RE: 13804 Haines Ave. NE

Grading and Drainage Plan Engineer's Stamp Date: 08/11/20

Hydrology File: J23D027

Based upon the information provided in your submittal received 08/11/20, the Grading and Drainage Plan is approved for Building Permit, Foundation Permit and Grading Permit.

SHEET NUMBER A-103

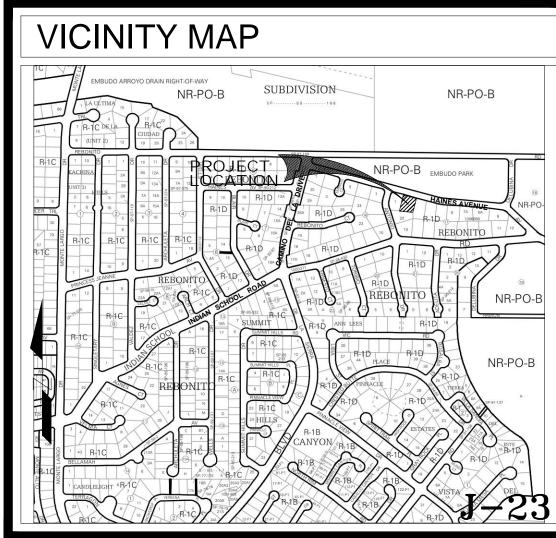
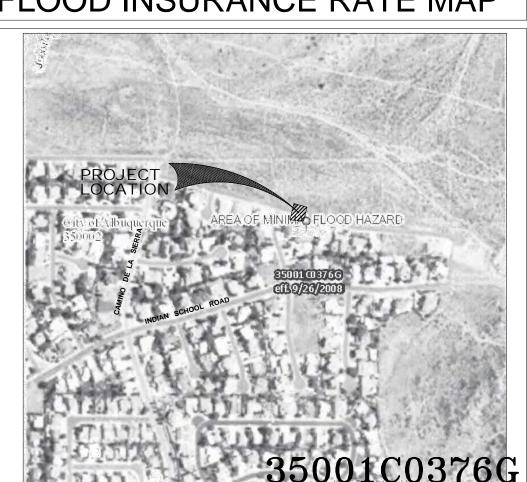
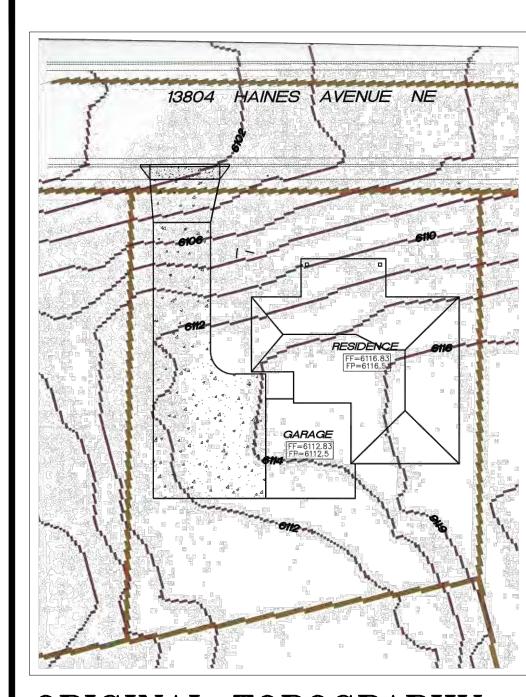
Once the grading is complete, a pad certification will be required prior to release of Building Permit. Please attach a copy of this approved plan in the construction sets for Building Permit

Prior to approval in support of Permanent Release of Occupancy by Hydrology, Engineer

Certification per the DPM checklist will be required.
